Background Information & Staff Comments
City of Springboro Planning Commission Meeting
Wednesday, January 11, 2017, 6:00 p.m.

- A. Rezoning, Eastbrook Farms, Northeast Corner West Central Avenue and Clearcreek-Franklin Road, from O, Office District, and R-2, Low-Density Residential District, to PUD-MU, Planned Unit Development-Mixed Use, retail and residential development**
- B. General Plan, Eastbrook Farms, Northeast Corner West Central Avenue and Clearcreek-Franklin Road, from O, Office District, and R-2, Low-Density Residential District, to PUD-MU, Planned Unit Development-Mixed Use, retail and residential development**

- D. General Plan, Easton Farm, 605 North Main Street, from R-1, Estate-Type Residential District, to PUD-MU, Planned Unit Development-Mixed Use, retail and residential development**

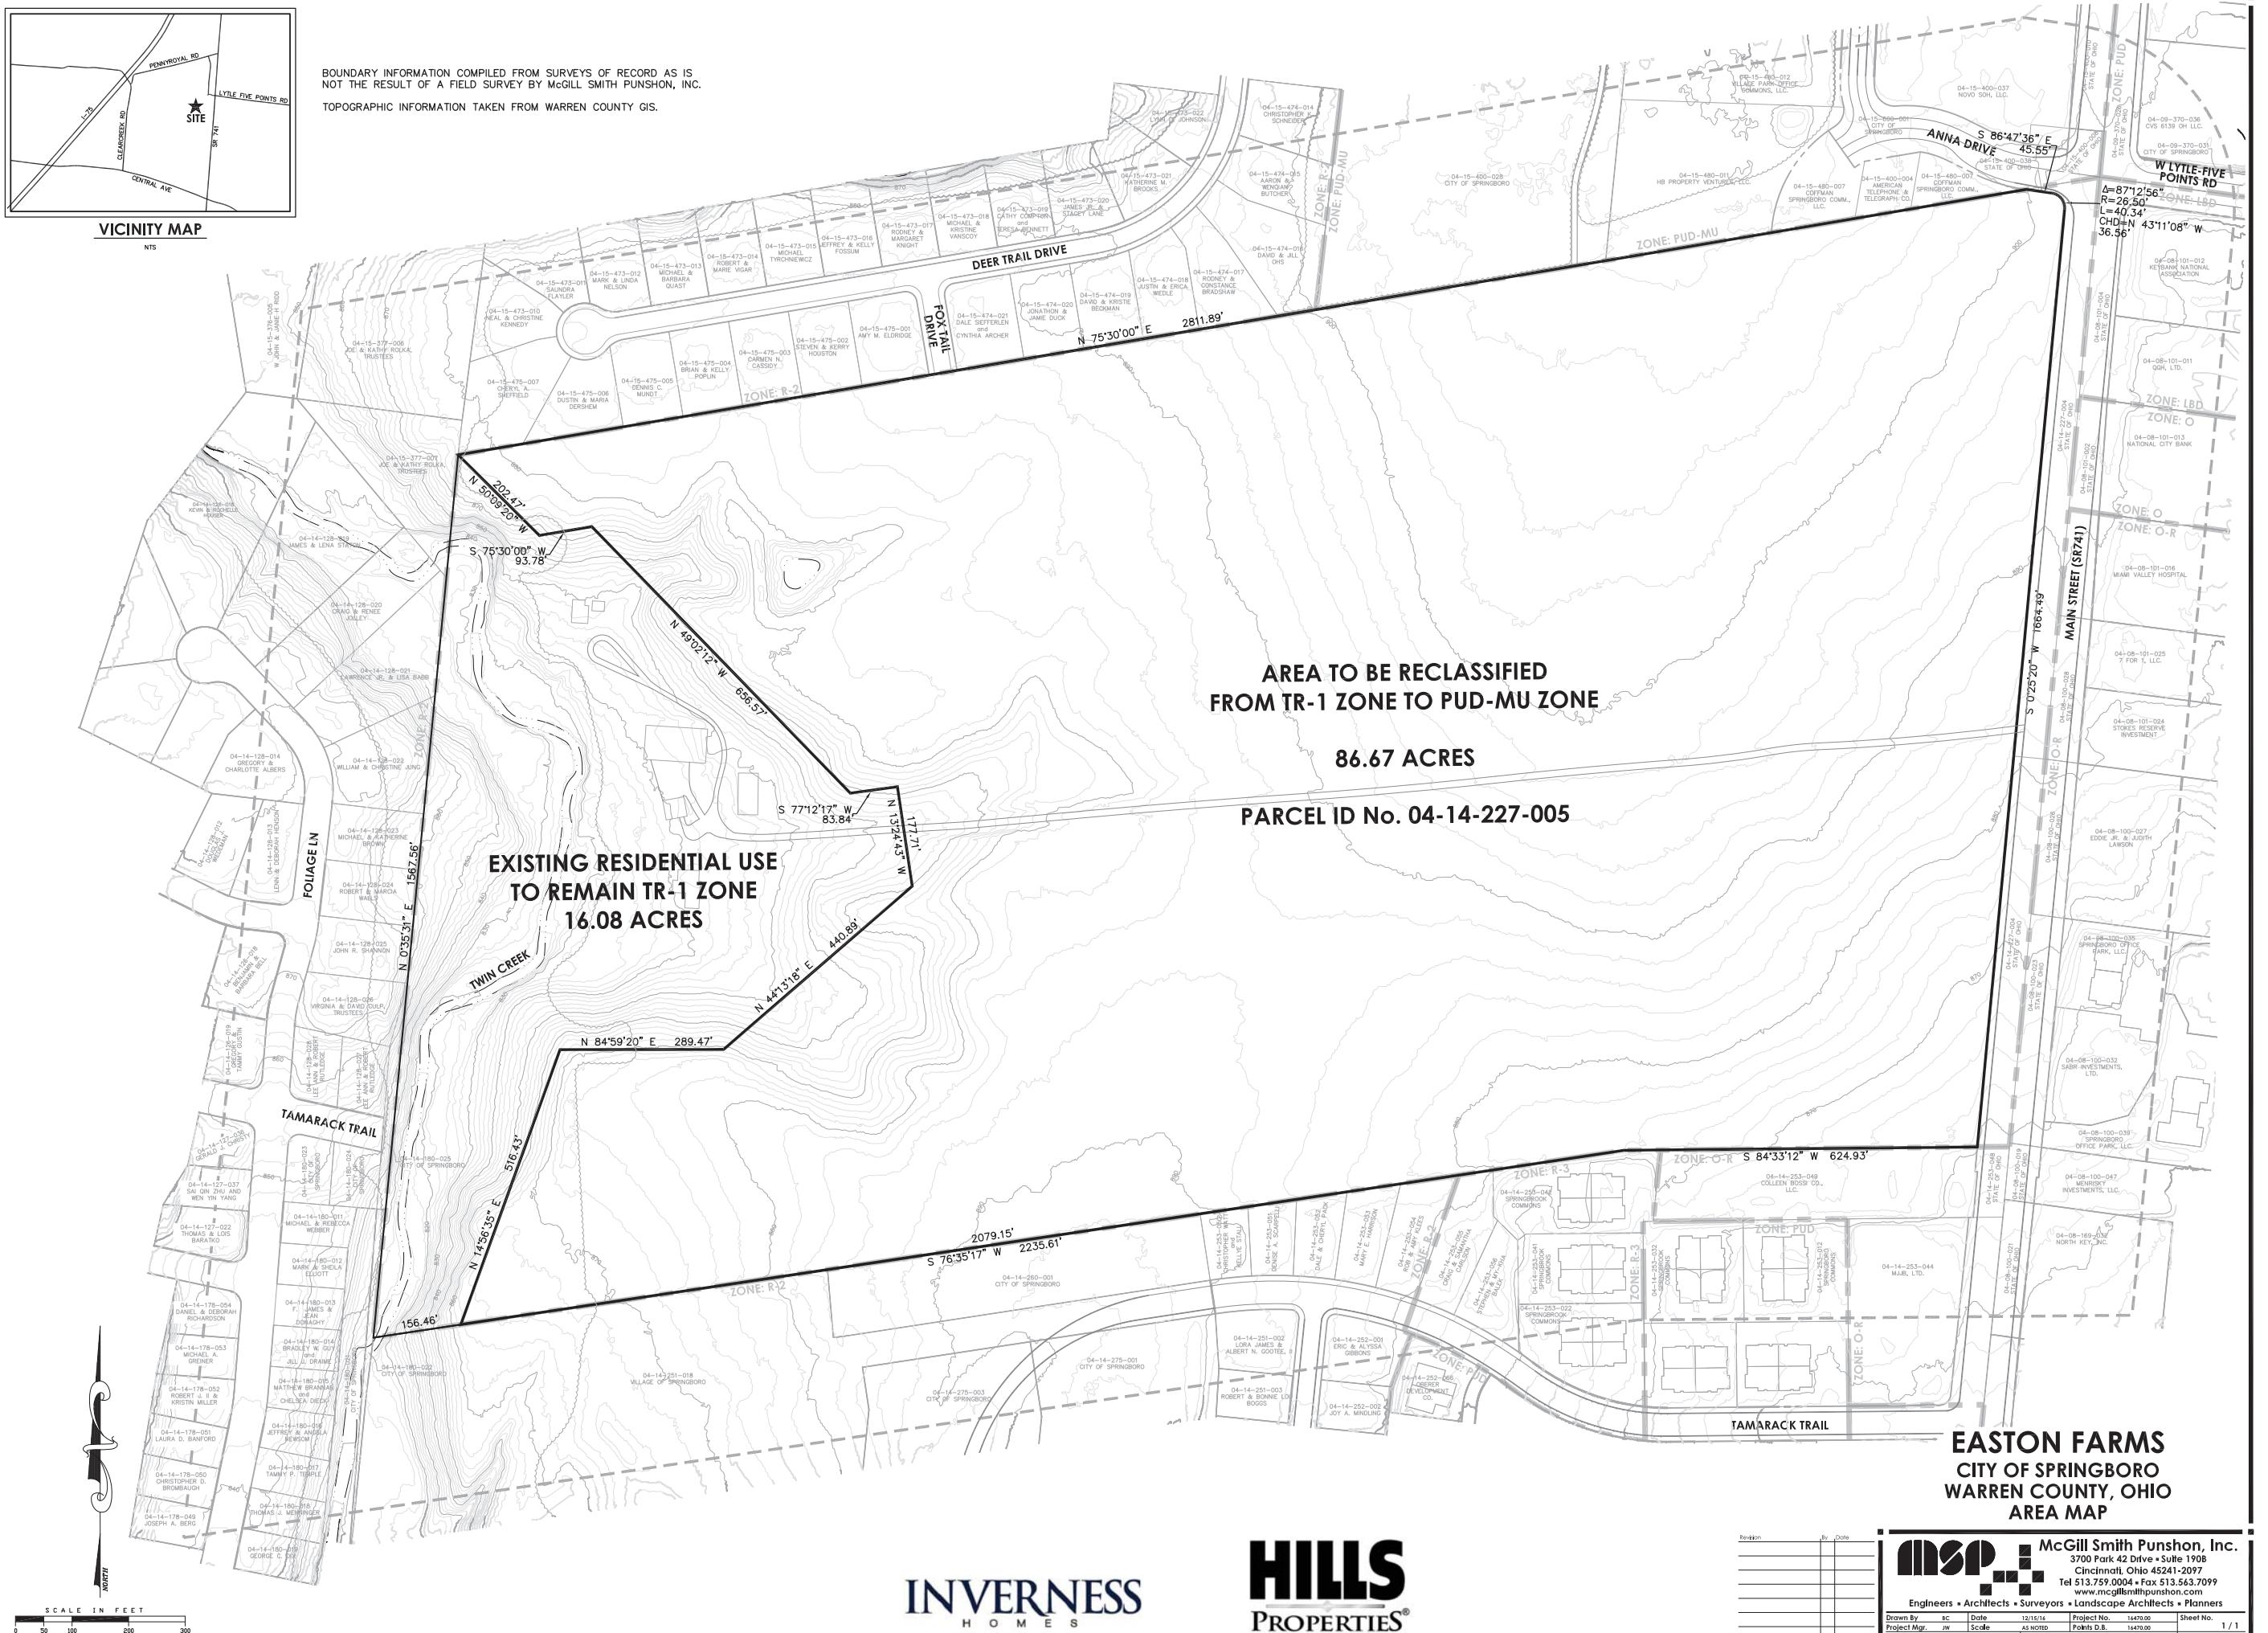
The applicant's General Plan concept drawing proposes a 17.24-acre of commercial development component along the North Main Street frontage on the east side of the property. A 33.95-acre single-family residential component is proposed for the south central portion of the subject property at a proposed density of 2.92 dwelling units per acre. To the north, an 18.55-acre area of apartments and townhouses are proposed for the north central portion of the subject property at a density of 16.82 dwelling units per acre. A second, 8.16-acre townhomes/attached area is proposed to the west with a development density proposed at 6.37 dwelling units per acre.

The proposed General Plan indicates vehicular access will be provided at North Main Street as well as to connections to the existing road network at Anna Drive and Fox Trail Drive to the north. Two right-in/right-out connections are also shown on North Main Street. No indication is provided on the General Plan is the vehicular access is proposed to be signalized. A traffic impact study has been submitted to City staff and is currently under review.

4. Indicate how the proposed plan complies with the 2009 City of Springboro Land Use Plan, Policy Area #3, North SR 741 Corridor, preferred land uses and characteristics, specifically the maximum preferred density of 6-8 dwelling units per acre.

6. The General Plan does not provide an indication of the base conventional zoning districts for the single family, townhouse and apartment components.

8. What percentage of the proposed open space is afforded to the storm water management and otherwise required setbacks and buffers?
9. The 16.08 acres on the west edge of the property is landlocked under the proposed General Plan. Provide access and frontage in compliance with City Subdivision Regulations.

11. Provide a direct connection to Tamarack Trail/Park Lane to the east of the entrance to North Park.
12. Provide a typical cross section of the proposed primary road network rights-of-way include sidewalks and tree lawns. Also provide a typical cross section of the proposed multiuse trail.

13. Provide an indication of the secondary road system within the components in the General Plan including a typical cross section showing proposed sidewalks, trails and tree lawns.
